Hill roads and sporting estates – the Glen Banchor/Pitmain “forestry” bypass is back

The differences between the current and the previous application

Brown line shows line of road in previous application, the blue between the two red lines the current application. The woodland plan, accompanying the application, shows a different line for the forestry road and I have marked this (approximately) in yellow.

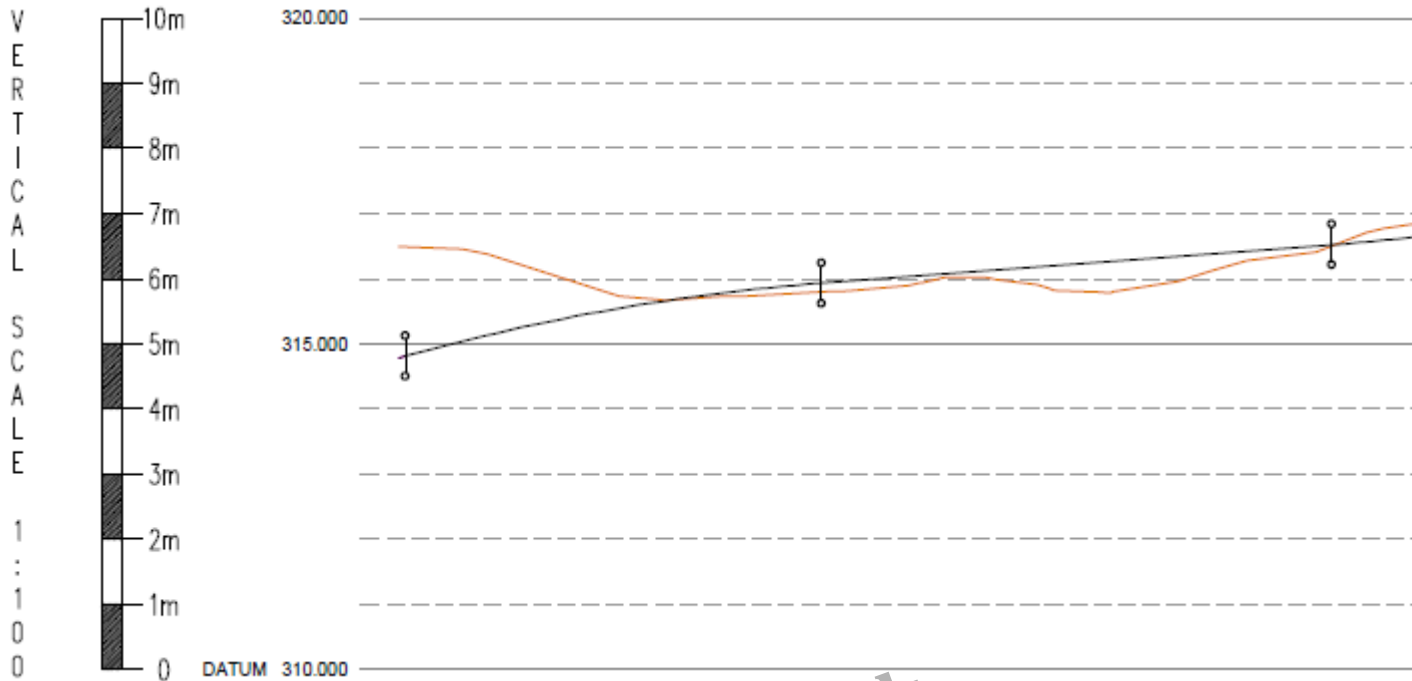
The main difference between the new application ([see here](#) for planning papers) and the previous one is the line taken by the proposed road, described in the application form as a “revised location”. The proposed road now follows a lower route round the hill, presumably following advice from CNPA planning officers that if the estate really wanted to press ahead with a planning application this could reduce its visual impact.

Extract from Long Section, the brown line shows the ground as it currently is, the black line the level road will be “smoothed”.

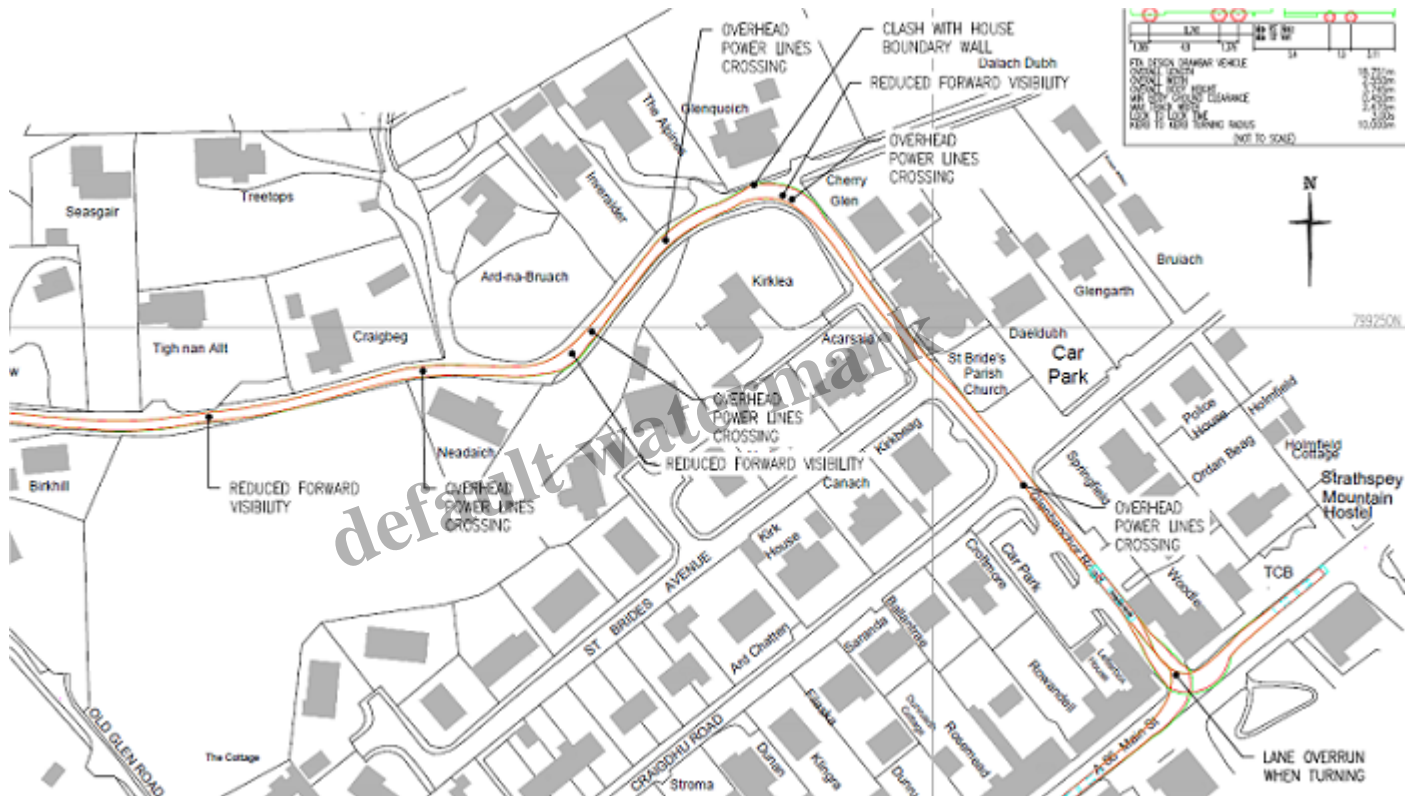
The other main difference that I have been able to establish – there is no clear statement of the differences in the planning documents – is the number of borrow pits. These have been reduced from several to one by dint of using bulldozed material from excavated sections to fill in dips in the ground.

Besides these two differences, there are many more documents than there were in the previous application. All of which date from when that application was still being discussed with the CNPA and may well have been provided as a result of their advice. These include a “Swept path analysis” – jargon for a road survey – visualisations of the proposed route, a peat survey and the Supporting Statement. Essentially, however, it is the same application and has been justified for the same reasons, that the road is necessary for forestry purposes.

“Swept analysis” for first part of Glen Rd which runs from the Main Road in Newtonmore up into Glen Banchor

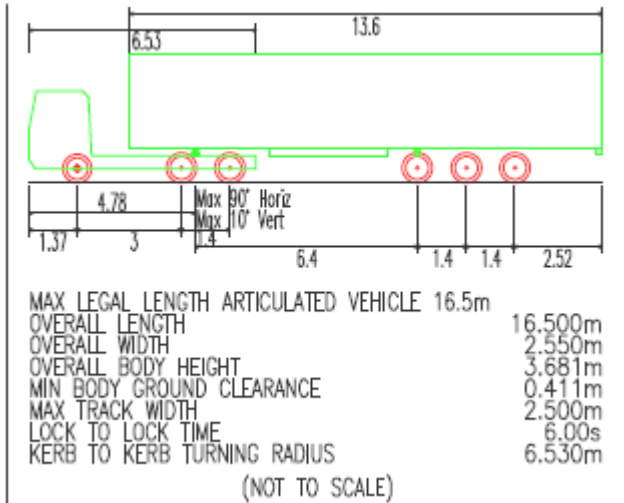
The inclusion of a number of “Swept Analyses” of Glen Rd in the new application, annotated with comments like “Reduced Forward Visibility” and “overhead power lines crossing” are meaningless without an analysis of how this would effect timber extraction. For example, the Electricity Supply Regulations ([see here](#)) set a minimum height for overhead powerlines crossing roads of well over 5m which is significantly greater than the height of the lorries included in the analyses:

If full-size bin lorries can use the road safely at present – I have seen them – why couldn't smaller timber lorries do the same? The supporting documents avoid this question because it undermines the ostensible rationale behind the application.

Annotations in bold capitals

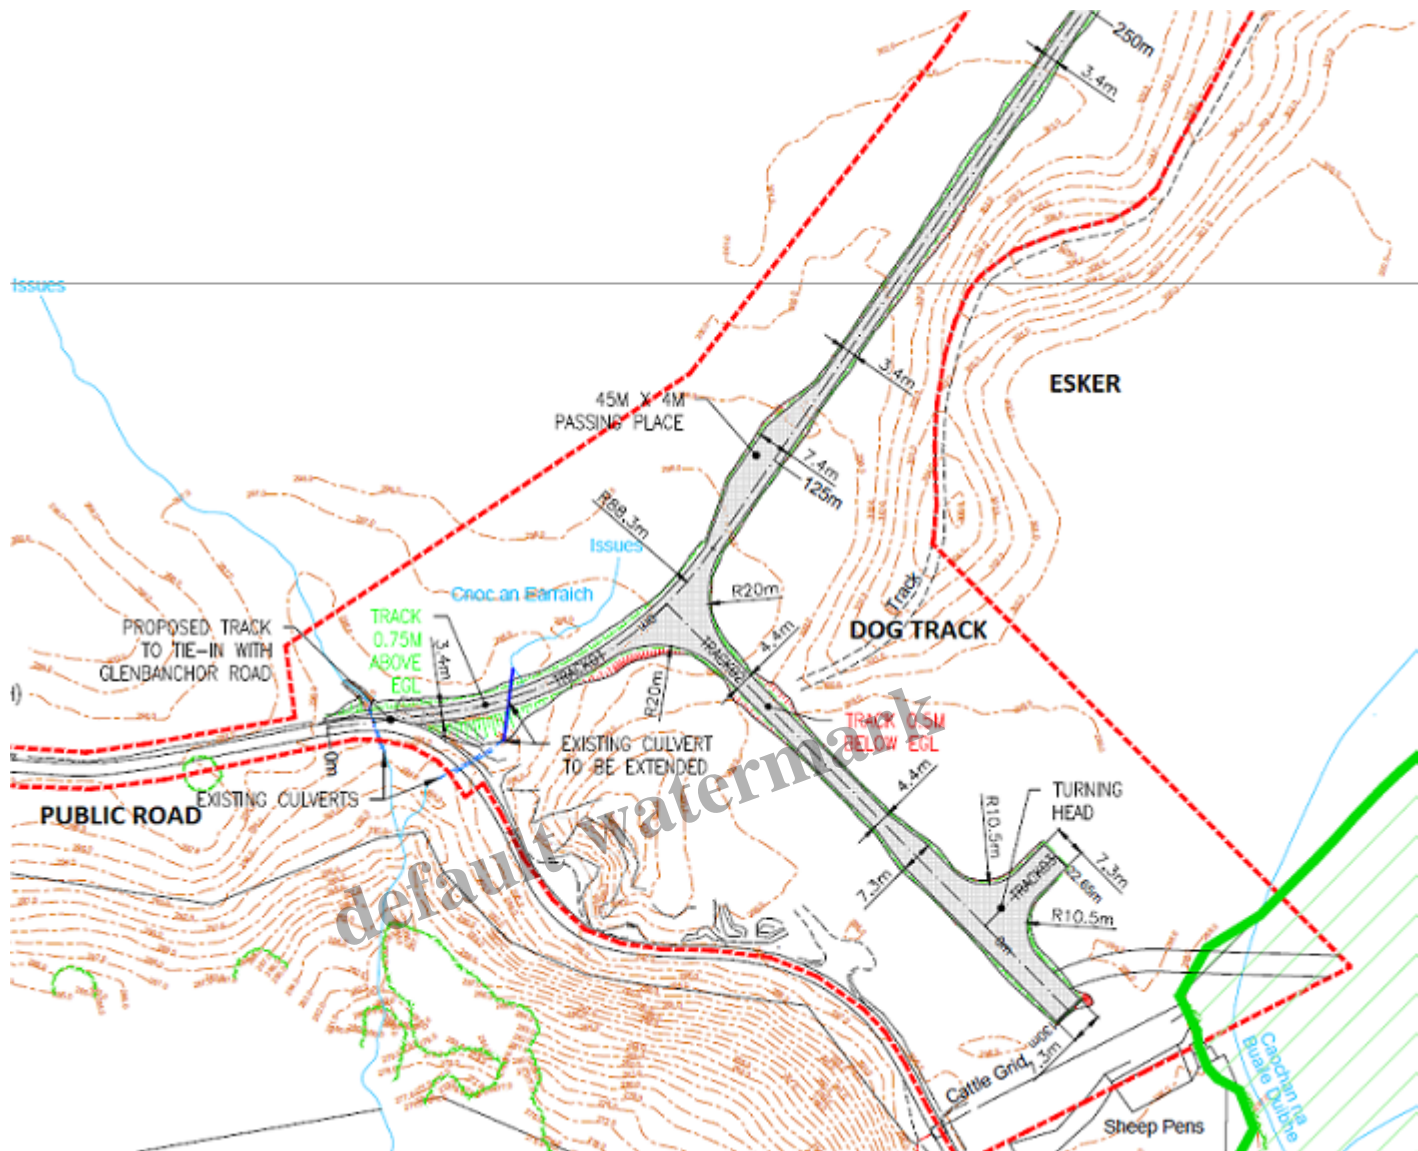
The maps in the application are a better source for evaluating the landscape impact of the new road network. Below is the map showing where the new road would connect with the public road in Glen Banchor, together with a connecting branch to the windthrown plantation to the south:

Note the 45 x 4m passing place, one circa every 200m along the road, and the “turning head”. None of this is evident from the visualisations. The two roads in parallel, one on top and one below the esker, shows just how little regard the Pitmain Estate and the consultants who work for them have for the Scottish landscape.

The green hash marks embankments, the blue the drainage ditches.

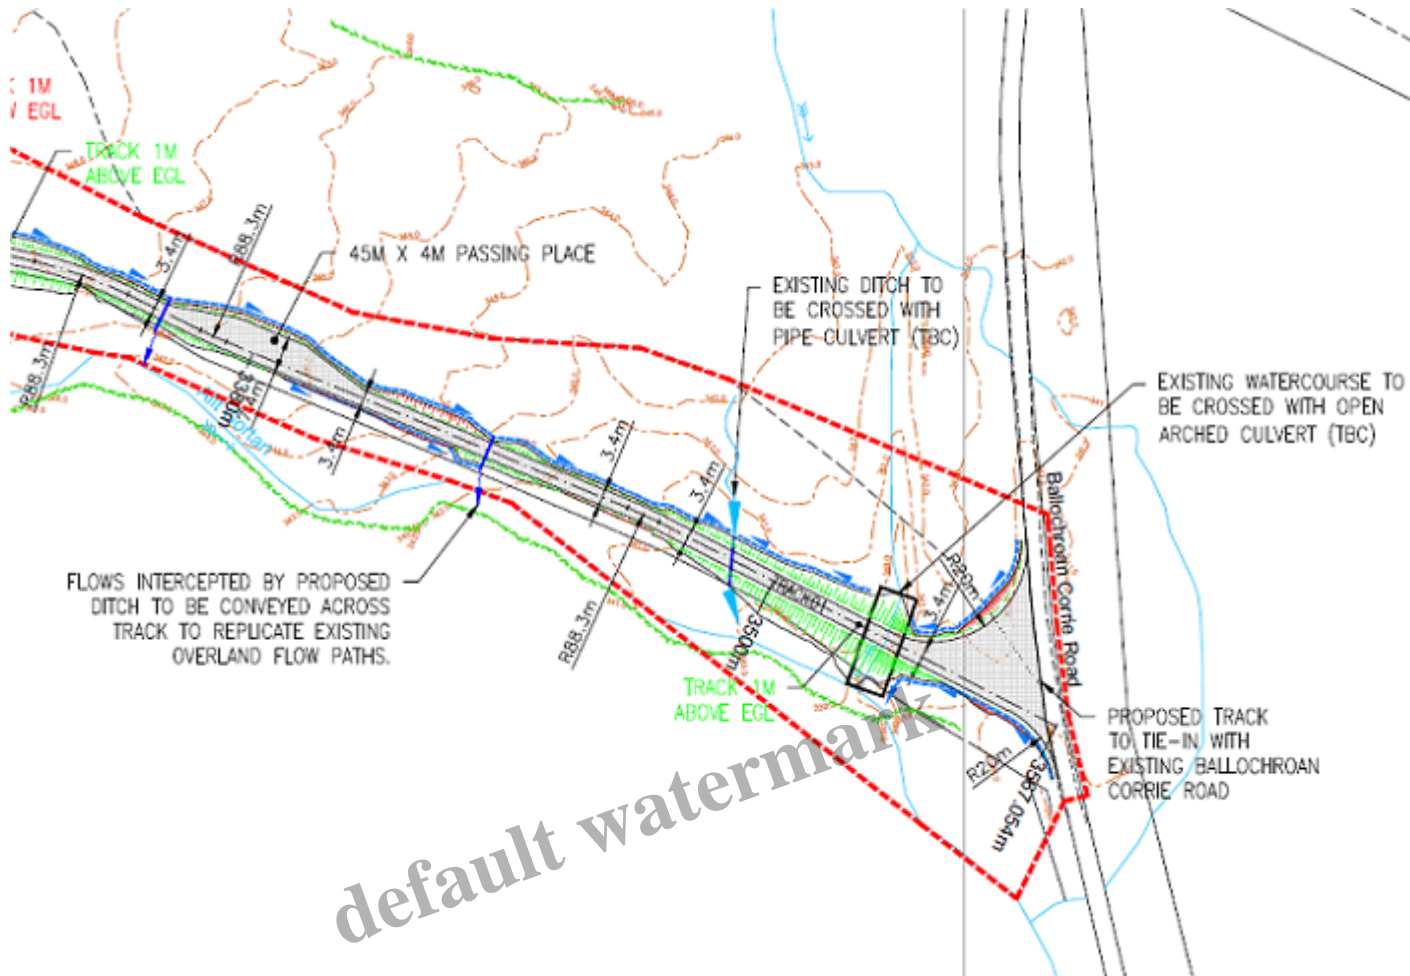
The suburbanisation of the landscape and another indication of the real purpose of the road is also evident at the other end where it meets the Ballachroan Road:

Why the need for a junction opening 20m wide? And why does this also face both ways if the purpose is for timber lorries coming from below (the bottom of the photo)? It appears the owners of the Pitmain Estate, their staff and guests want to be able to get to places fast (hence too all the passing places).

Section close to the junction with the Strone Rd: the red shows a cutting, the green an embankment (which will be covered by a “rock blanket”) and the purple a retaining wall.

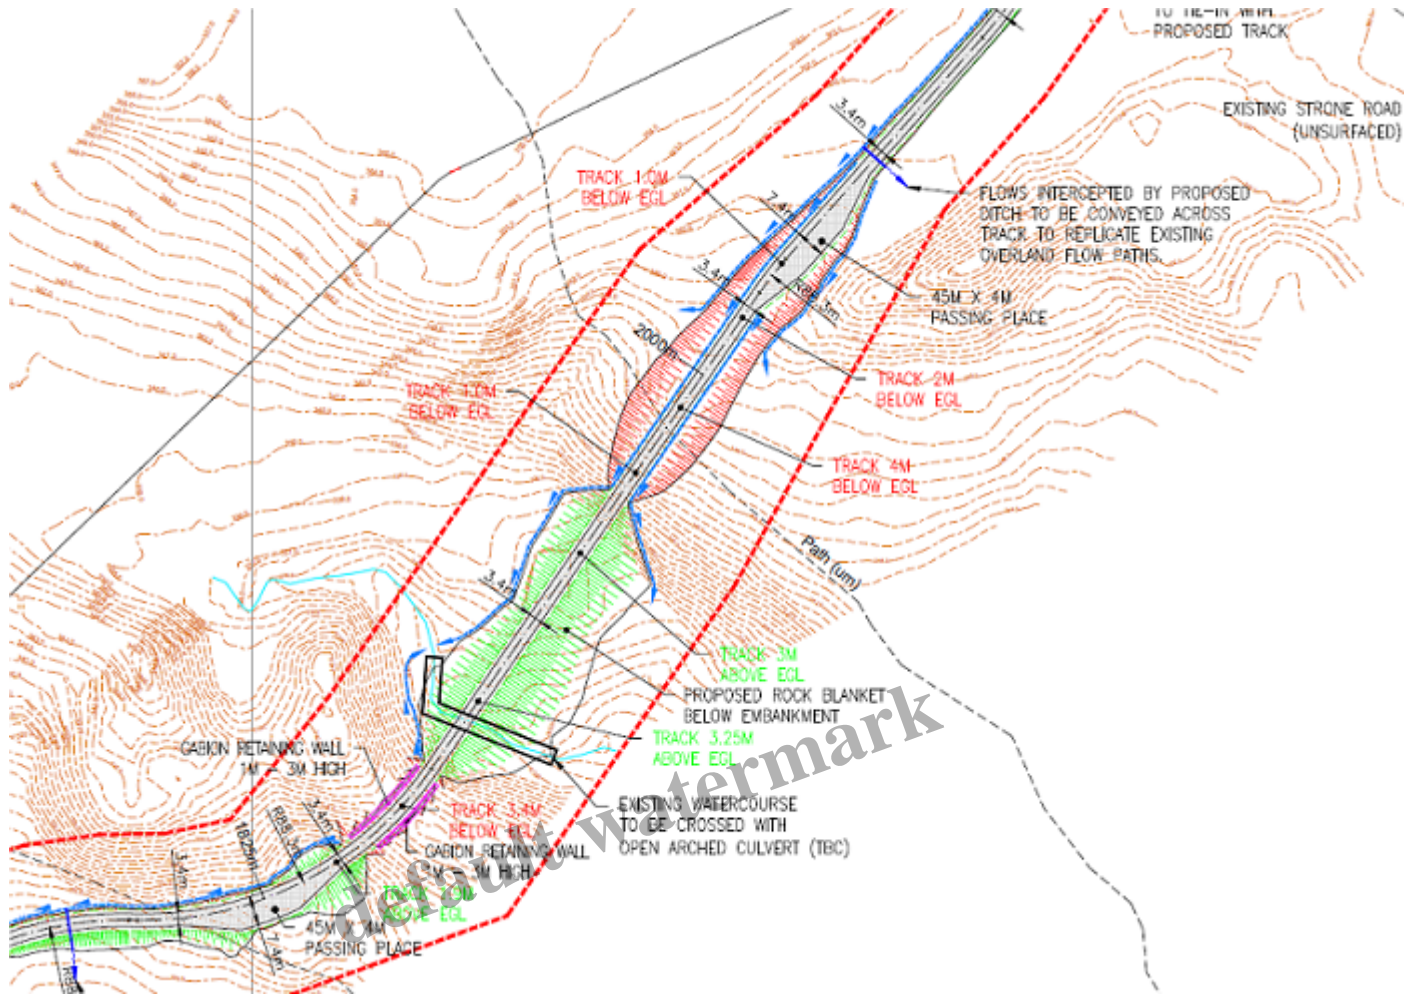
From a landscape perspective, the application fails to assess the impact of the cuttings and embankments which are shown in the plans:

The Design Statement claims that the road construction is in accordance with SNH guidance on “Constructed tracks in the uplands” ([see here](#)). A cursory glance at that guidance, which starts by suggesting alternatives- like the public road in Glen Banchor! – should be examined before deciding to build new roads, shows that this is not the case. There is even a diagram (page 35) advising that roads should not be constructed in straight lines up slopes as is proposed above!

Following a direct route will require cutting and rock exposures. The straightness of the route is likely to conflict with the chaotic nature of this landscape

Note that with the verges and ditches the proposed road will impact an area 7 metres wide (and far more where there are passing places)

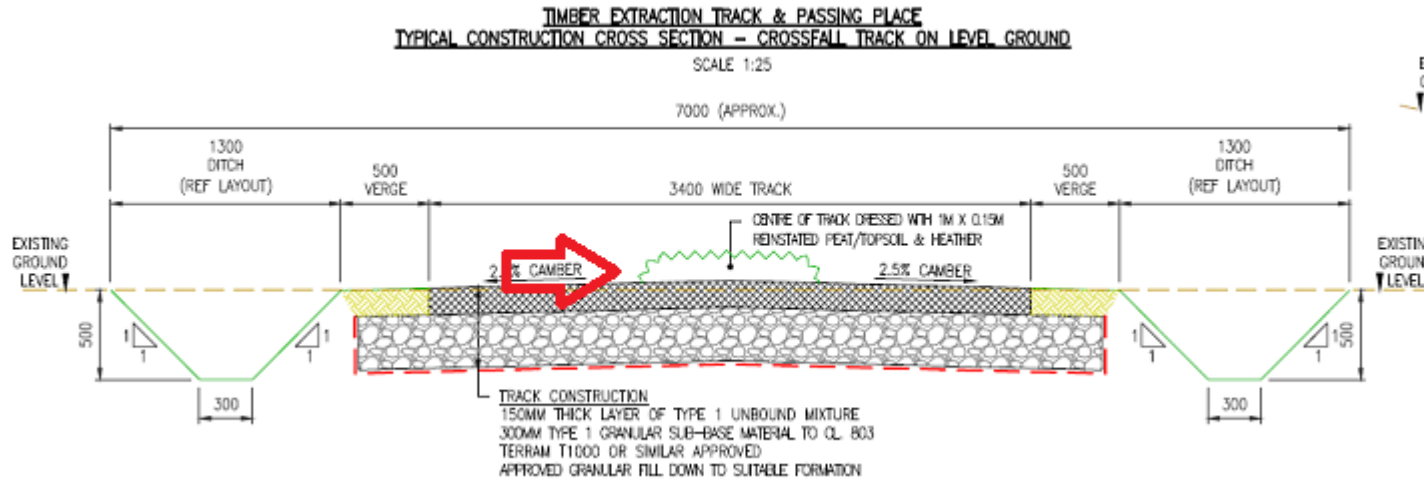
While also not clearly stated in the Design Statement, it appears from the diagrams that the Pitmain Estate is proposing to use some of the "surplus" peat from the road construction to create a vegetated strip down the middle of the road:

While vegetated strips down hill roads are generally welcome, re-using peat to create them will destroy that peat and will be like using peat as garden compost. Peat is created and develops in water-logged conditions but the centre of the track is well drained so any water that is in the peat will drain out the sides. This peat will therefore quickly degrade releasing carbon into the atmosphere.
